## Proposal for the 01 series of amendments to UN Regulation No. 136 (specific requirements for the electric power train of vehicles of category L)

### Submitted by the expert from IMMA

The text reproduced below was prepared by the experts from IMMA to amend the provisions concerning the approval of vehicles of category L with regard to specific requirements for the electric power train, to introduce updated provisions from the new 03 series of amendments to UN Regulation No. 100 (ECE/TRANS/WP.29/2020/109), adopted by WP.29 at its 182<sup>nd</sup> session in November 2020.

"Figure 1  
**Jointed Test Finger**

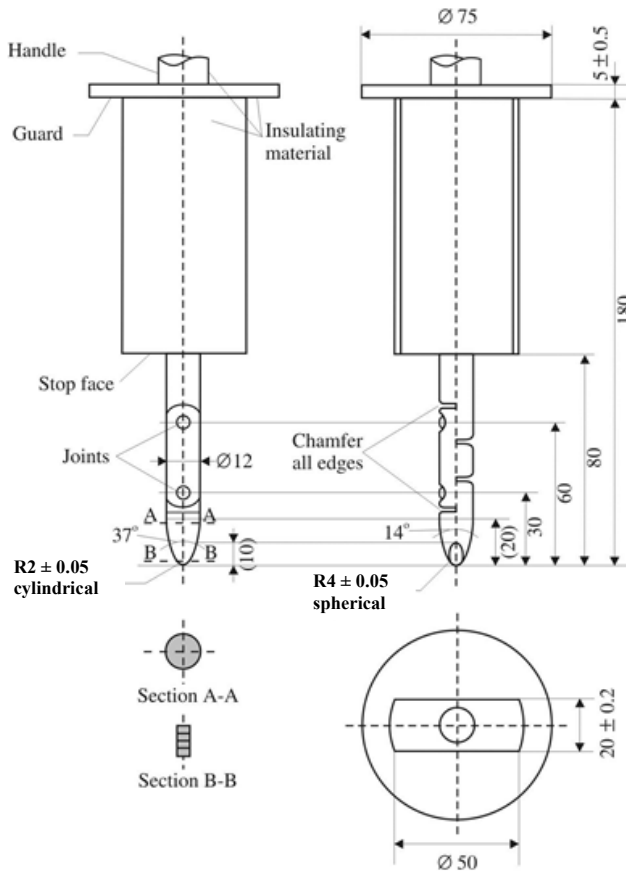
In ~~the~~ case of the test for **protection degree IPXXB**, the jointed ...

In case of the tests for **protection degree IPXXD**, the access probe ..."

*Annex 3, Figure 1*, shall be deleted.

Annex 3, insert new Figure 1 to read:

Example of Test Method using DC Power Supply

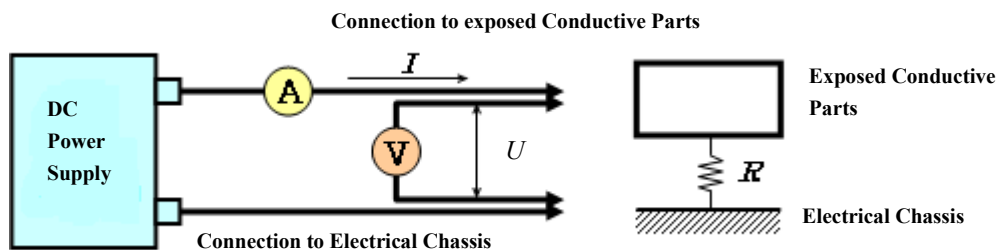
Throughout new Annex 5A and Annex 5B (including Figures), replace the symbols for voltage, V, V<sub>b</sub>, V<sub>1</sub>, V<sub>1</sub>', V<sub>2</sub>, V<sub>2</sub>', with U, U<sub>b</sub>, U<sub>1</sub>, U<sub>1</sub>', U<sub>2</sub>, U<sub>2</sub>'.
